**Facility-Specific Information Relative to General Electric
Licensing Topical Report NEDC-32410P-A**

Nuclear Measurement Analysis and Control Power Range Neutron Monitor
(NUMAC-PRNM) Retrofit Plus Option III Stability Trip Function

Edwin I. Hatch Nuclear Plant
Request to Revise Technical Specifications:

Edwin I. Hatch Nuclear Plant
Request to Revise Technical Specifications:
*Power Range Neutron Monitor Retrofit
and
Oscillation Power Range Monitor*

~~Figure 3.4.1-1 (Page 1 of 1)
Power Flow Operating Map with One Reactor
Coolant System Recirculation Loop in Operation~~

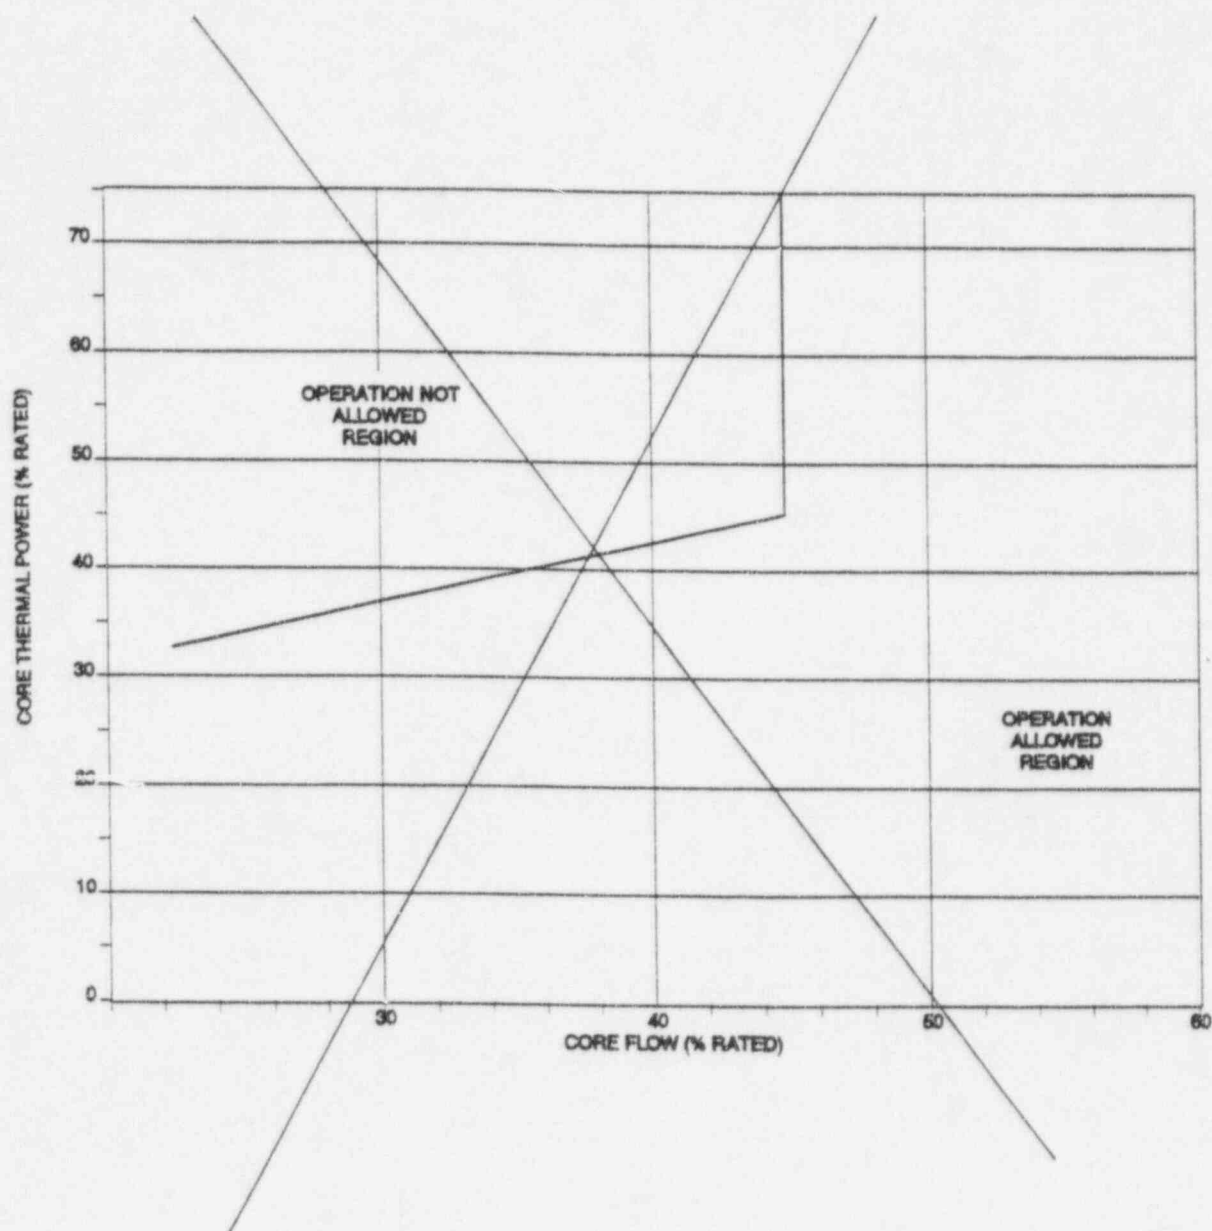
Limiting Condition for Operation 3.4.1.b is removed to reflect deletion of Figure 3.4.1-1, "Power-Flow Operating Map with One Reactor Coolant System Recirculation Loop in Operation." The corresponding Action B of this LCO and SR 3.4.1.2 are deleted.

Both the power-to-flow map for single loop operation (SLO) and the requirement for immediate shutdown with no recirculation pumps in operation were Technical Specifications requirement prior to the LaSalle thermal-hydraulic oscillation event in 1988. Both requirements are not contained in NUREG-1433 (the BWR/4 Improved Technical Specifications). Although exhaustive search with similar BWR plants was not performed, GPC believes these two Technical Specifications requirements are unique to Plant Hatch. The proposed changes described above are now identical to NUREG-1433.

Approximately 10 years ago, Figure 3.4.1-1 was placed in the Technical Specifications when the NRC approved Unit 1 Amendment 141 and Unit 2 Amendment 77 to allow continuous SLO. The figure provided a restricted region of operation during SLO and was an alternative to placing certain recommendations of GE Service Information Letter (SIL) 380 in the Technical Specifications. The requirement to place the mode switch in shutdown immediately after a loss of both recirculation pumps has been in the Unit 1 and Unit 2 Technical Specifications for many years. The Technical Specifications of other plants similar to Plant Hatch provide several hours to restart a recirculation pump before entry into MODE 3 is required.
